CUDIA CITY WASH

FLOOD HYDROLOGY

**FOR THE DESIGN OF THE
ARIZONA CANAL DIVERSION CHANNEL**

**CITY OF PHOENIX
ENGINEERING DEPARTMENT**

FIGURE 1

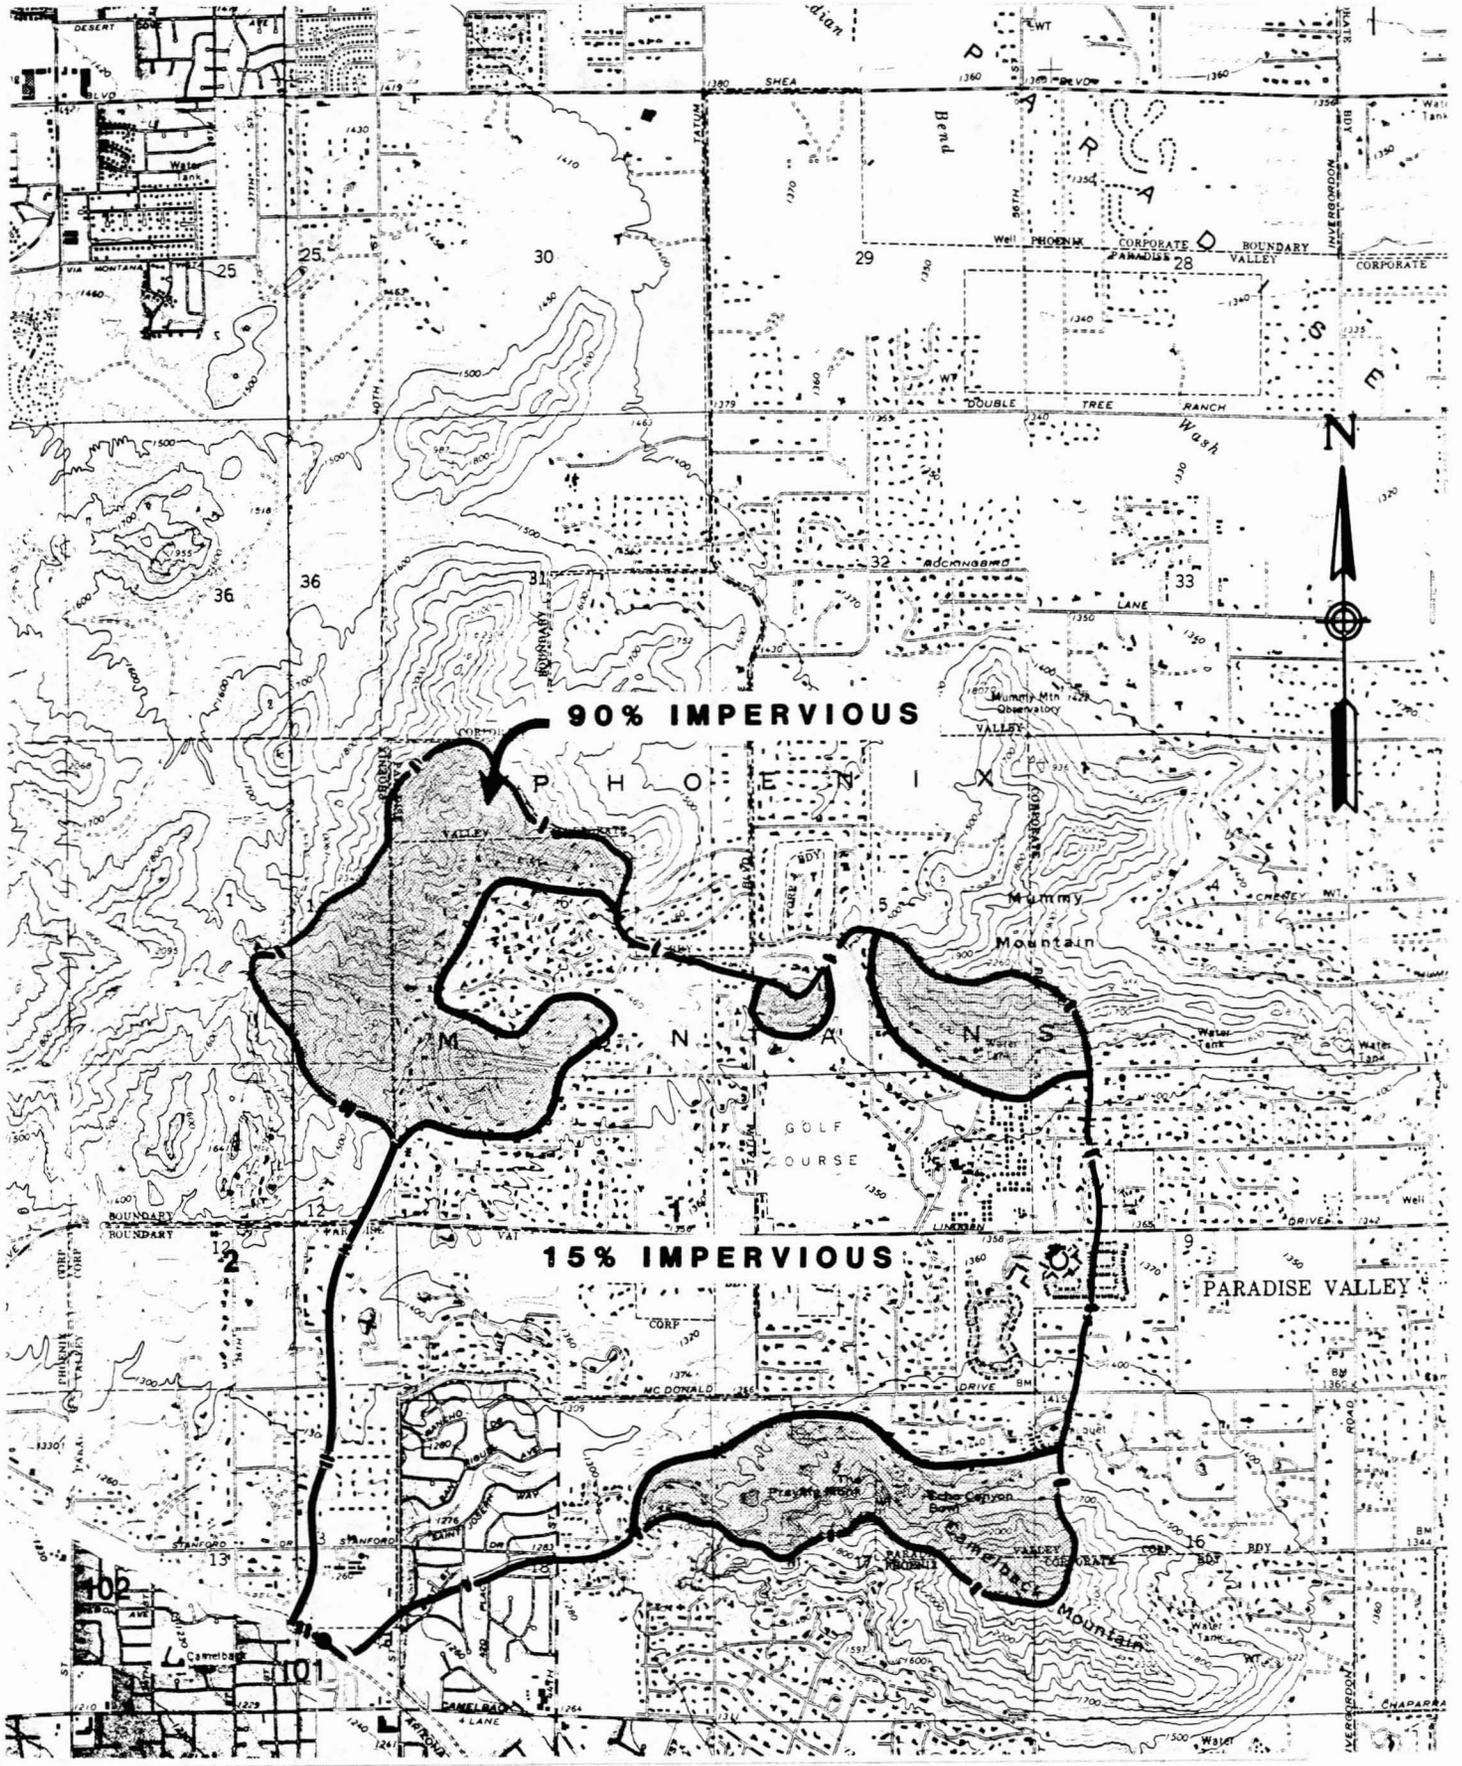
An independent check was performed on the amount of impervious area within the watershed. An outline of the watershed is shown in Figure 1, and the mountain outcropping from the land surface is stippled and is about 28 percent of the watershed. The non-stippled area is generally desert, single-dwelling houses, contains a golf course, and is about 72 percent of the watershed. WSG estimated that the impervious cover of the non-stippled area is 15 to 18 percent (SWG, 1987, pg. 36). If the mountains are 100 percent impervious and the remaining area is 15 percent impervious then the area weighted imperviousness is 39 percent, which agrees very well with the estimate by the Corps of Engineers. The mountains will have some pockets of soil cover and if it is assumed that the mountains are 90 percent impervious then the area weighted imperviousness is 36 percent. The estimate of 12 percent imperviousness by WSG does not seem justified.

WSG used a CN of 86.35. This may have been based on the estimate of 12 percent imperviousness and an evaluation of soil-vegetation complexes in the watershed. If the watershed imperviousness is 36 percent, than the CN would be higher. This would result in greater volumes of rainfall excess and much higher peak discharges than estimated by WSG.
